CEDAR & SAINT SUBDIVISION

Engineering Comments: **FINAL PLAT COMMENTS** (should be addressed prior to submitting the FINAL PLAT for review and/or signature by the City Engineer):

APPLICATION NUMBER 10 DATE June 17, 2021

DETAIL SITE PLAN

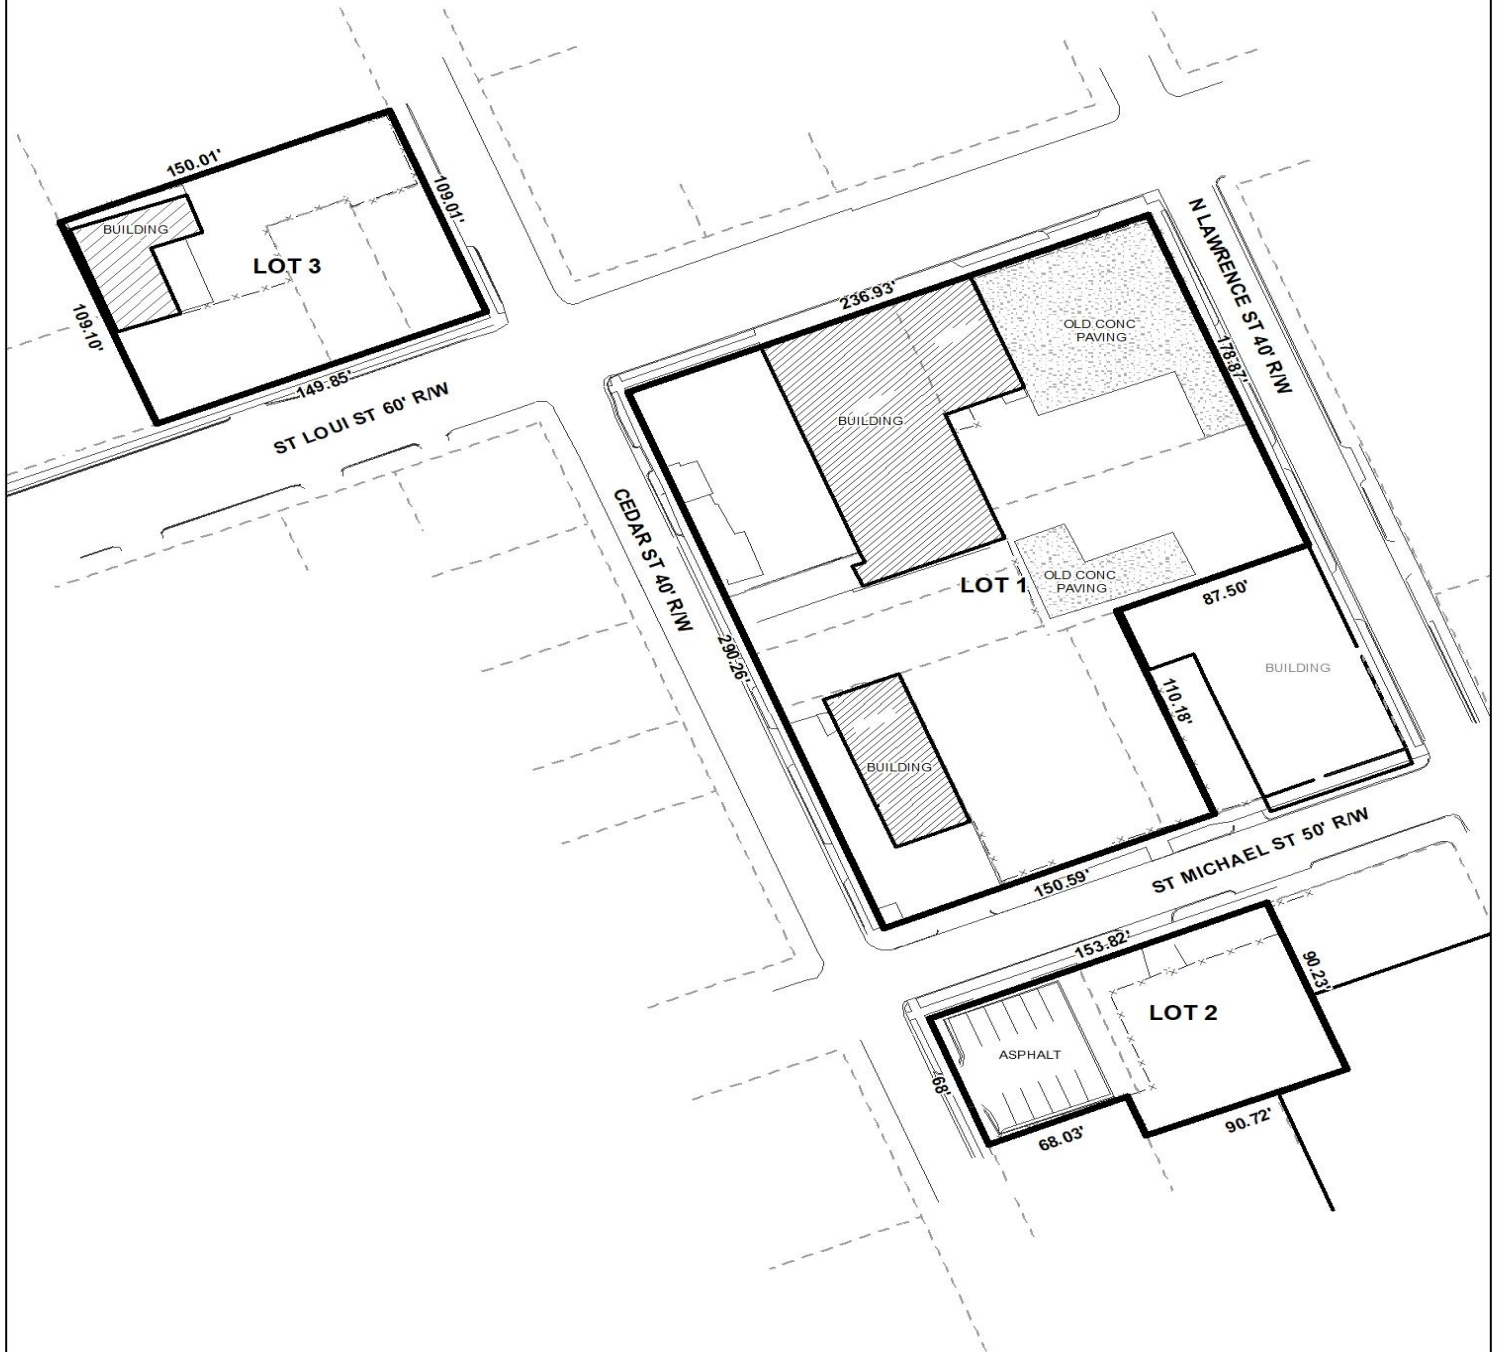
- A. Provide all of the required information on the SUBDIVISION PLAT (i.e. signature blocks, signatures, certification statements, written legal description, required notes, legend, scale, bearings and distances) that is required by the current Alabama State Board of Licensure for Professional Engineers and Land Surveyors.

- B. Add legible street names to the vicinity map.
- C. Label the LOTS 1, 2, and 3 on the Vicinity Map.
- D. Show and label all flood zones – X(shaded) and X(unshaded).

- E. Revise SURVEY NOTE #3 to reference the current FEMA maps. New maps went into effect on June 5, 2020.
- F. Show and label the MFFE (Minimum Finished Floor Elevation) on each lot that contains an AE, V, or X (shaded) flood zone designation. Current BFE = 11.0

- G. Provide a thicker line weight for the proposed boundary of each LOT.
- H. Provide and label the monument set or found at the northwest subdivision corner of LOT 3.

- K. Add a note to the SUBDIVISION PLAT stating that as shown on the 1984 aerial photo (FLIGHT 30 - #70) LOTS 1, 2, and 3 will receive historical credit of existing (1984) impervious area towards stormwater detention requirement per Mobile City Code, Chapter 17, Storm Water Management and Flood Control) as follows: LOT 1 – 45,000 sf, LOT 2 – 2,200 sf, and LOT 3 – 16,000 sf.

Per Section 64-3.1.Plate B of the Zoning Ordinance, St. Louis Street is designated as an “A street” with St. Michael Street, Cedar Street, and North Lawrence Street as “B Streets”. Section 64-3.I.8.(a).(1). states, “Properties abutting more than one (1) street shall designate a primary frontage. The primary frontage shall be an A street if one (1) is abutted.” As such, a note should be added to the Final Plat designating St. Louis Street as the primary frontage for Lots 1 and 3.

- 1) retention of the notes stating the minimum and maximum setbacks for all lots;;
- 2) retention of the lot size labels in both square feet and acres on the Final Plat or the furnishing of a table on the Final Plat providing the same information;

- 3) addition of a note to the Final Plat designating St. Louis Street as the primary frontage for Lots 1 and 3;
- 4) compliance with the Engineering comments: *(FINAL PLAT COMMENTS (should be addressed prior to submitting the FINAL PLAT for review and/or signature by the City Engineer): A. Provide all of the required information on the SUBDIVISION PLAT (i.e. signature blocks, signatures, certification statements, written legal description, required notes, legend, scale, bearings and distances) that is required by the current Alabama State Board of Licensure for Professional Engineers and Land Surveyors. B. Add legible street names to the vicinity map. C. Label the LOTS 1, 2, and 3 on the Vicinity Map. D. Show and label all flood zones – X(shaded) and X(unshaded). E. Revise SURVEY NOTE #3 to reference the current FEMA maps. New maps went into effect on June 5, 2020. F. Show and label the MFFE (Minimum Finished Floor Elevation) on each lot that contains an AE, V, or X (shaded) flood zone designation. Current BFE = 11.0 G. Provide a thicker line weight for the proposed boundary of each LOT. H. Provide and label the*

Based upon the preceding, and with a waiver of Sections V.B.14 and V.B.16. of the Subdivision Regulations, the plat is recommended for Tentative Approval, subject to the following conditions:
